Iris Fashion Ltd. MK Fashions Ltd.

Dewan Idrish Road, Zirabo, Savar, Dhaka-1341
(23.913390, 90.313304)
11th March 2014

Observations

Column Strengths

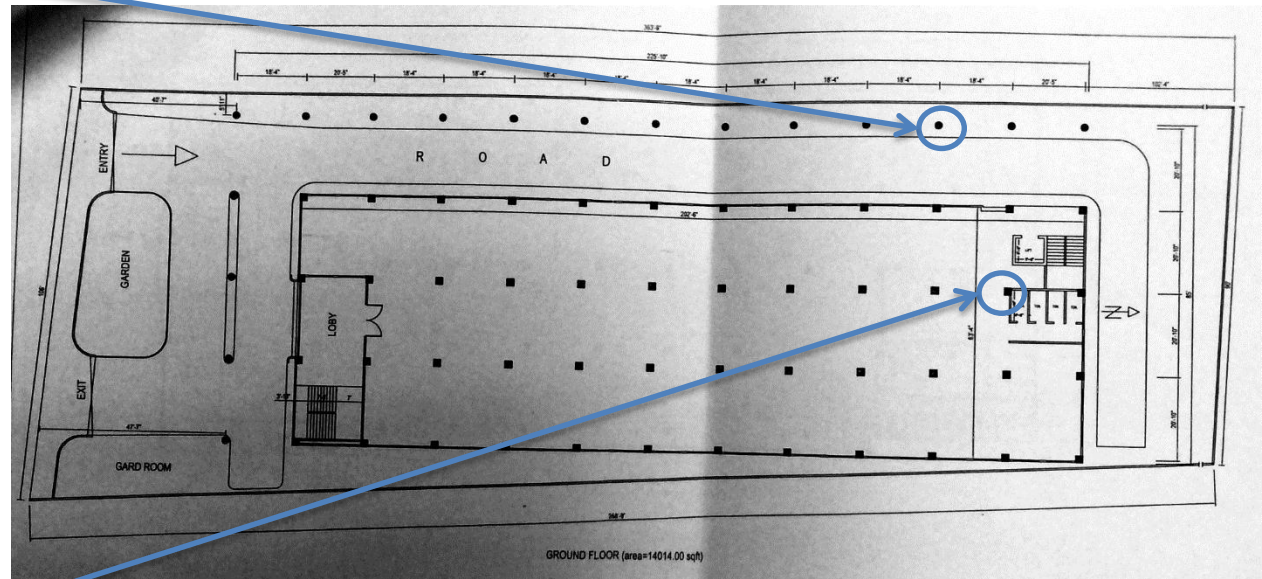
Perimeter column tested

Internal column tested

Opening up confirms aggregate type is stone throughout ground floor level columns.

Cursory calculations indicate working stress in some columns are high and warrant review and checking

Column strengths

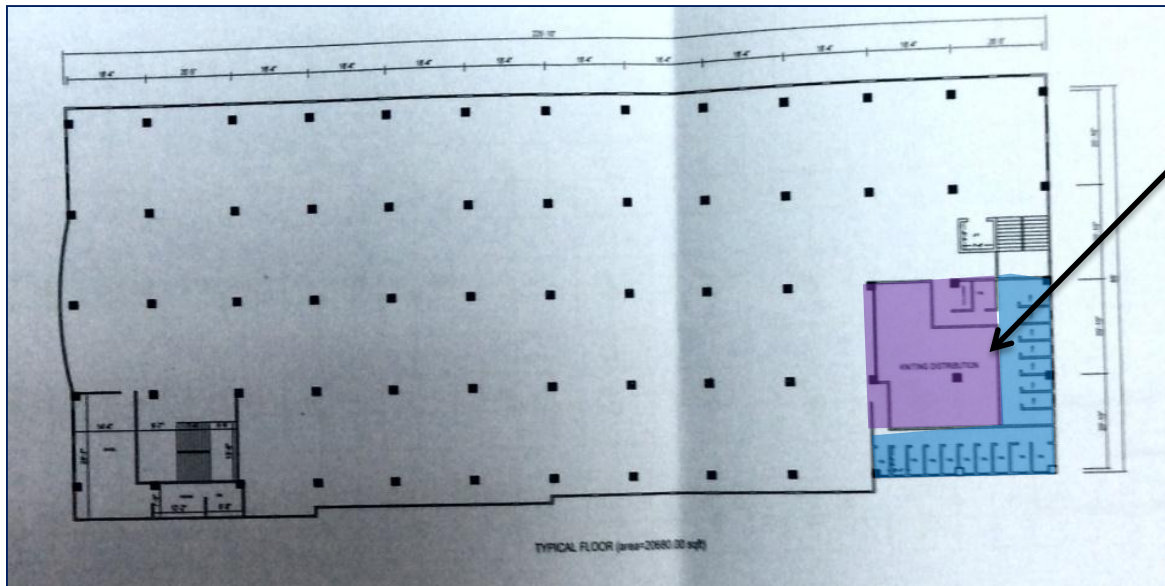
High loading due to storage areas, toilets and water tanks

High loads arising from heavy toilet floor build-up and dense arrangement of masonry partitions, sometimes cantilevering out from building column line.

Toilets are adjacent to main storage areas on all floors

Toilets and storage at this location on all floors

Item No.	Observation	Recommended Action Plan	Recommended Timeline
10	Check on Column and Slab stresses due to high loading in toilet areas.	Building Engineer to ensure the structure is not loaded beyond capacity by the loading from high build up in toilet areas as part of the Detail Engineering Assessment.	6-weeks
11	Check on Column and Slab stresses due to high loading in toilet areas.	Building Engineer to create controlled loading plans for all floors.	6-weeks
12	Check on Column and Slab stresses due to high loading in toilet areas.	Continue to implement load plan.	6-months
13	Check on Column and Slab stresses due to high loading in Washing/Drying area.	Building Engineer to ensure the structure is not loaded beyond capacity by the loading from high build up in Wash/Dry area as part of the Detail Engineering Assessment.	6-weeks
14	Check on Column and Slab stresses due to high loading in Washing/Drying area.	Building Engineer to create controlled loading plans for all floors.	6-weeks

Floor loading – washer areas

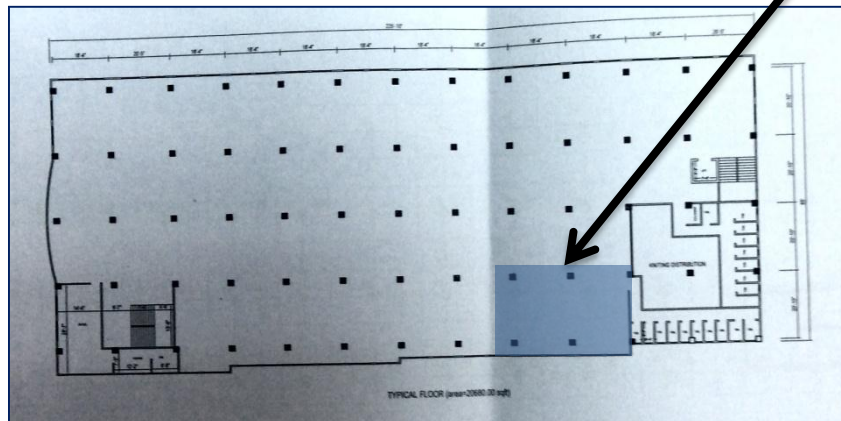
High local loads arising from heavy washer floor build-up and machines

Heavy washer build-up in this location on L1

15	Check on Column and Slab stresses due to high loading in Washing/Drying area.	Continue to implement load plan.	6-months

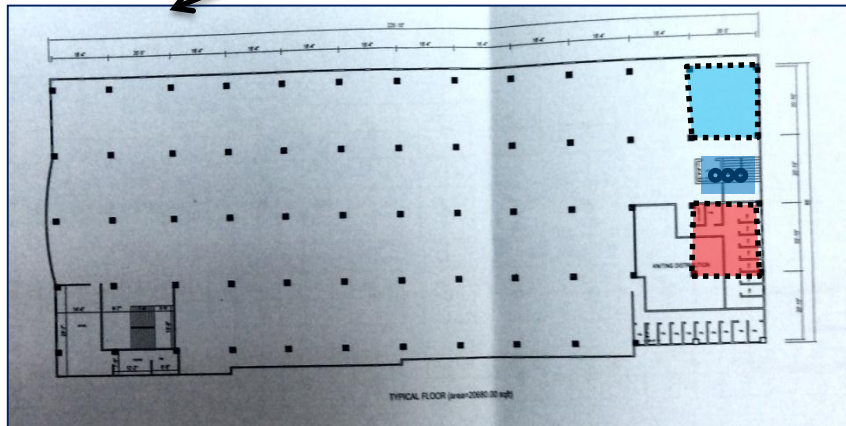
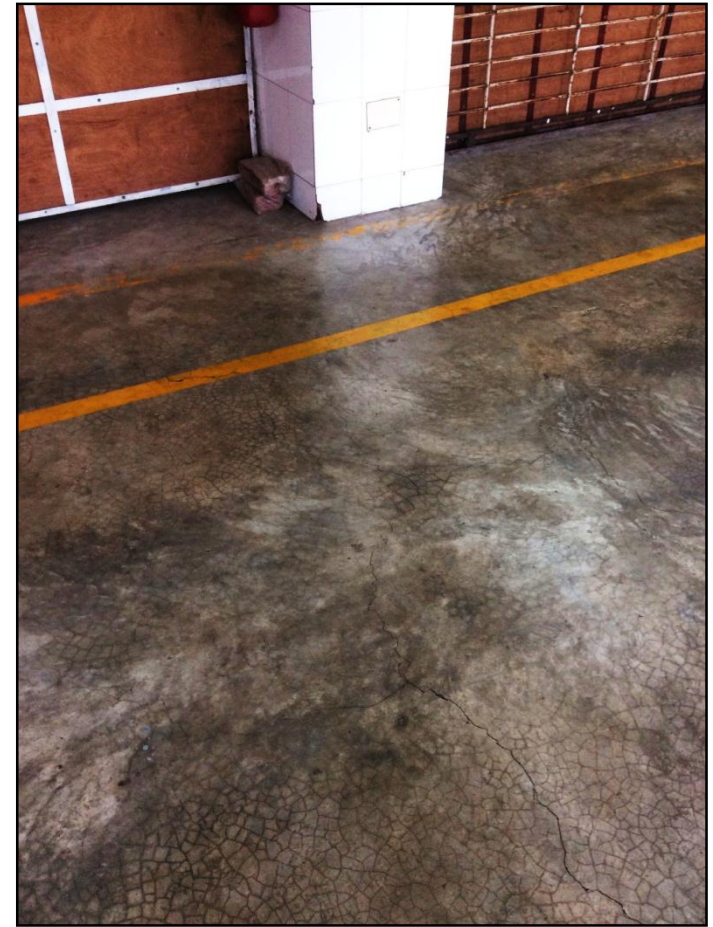
Water tank height 2.3m over 2 bays by stair core = 23kN/m^2

2 large concrete water tanks (Blue and red in diagram) at Level 9 by stair core not shown on drawings add significant load to supporting structure. Some concern with Red shaded tank and column loading

Other loading also arises from a group of 3 large plastic tanks at roof level over the stair core

Item No.	Observation	Recommended Action Plan	Recommended Timeline
16	Large water tank loading over stair core – concerns over column and slab stresses.	Building Engineer to ensure the structure is not loaded beyond capacity by the loading from the water tank as part of the Detail Engineering Assessment	6-weeks
17	Large water tank loading over stair core – concerns over column and slab stresses.	Building Engineer to create controlled loading plans for all floors	6-weeks
18	Cracking in surface of slab at Level 1	Engineer to investigate crack source/cause.	6-weeks
19	Cracking in surface of slab at Level 1	If cracks are structurally significant, remove all items above the slab and close working areas below the affected areas . Engineer to Check design, specify repairs and strengthening of the slab if necessary.	6-weeks
20	Complete parapet guarding at roof	Restrict access to area until infill work complete	6-weeks
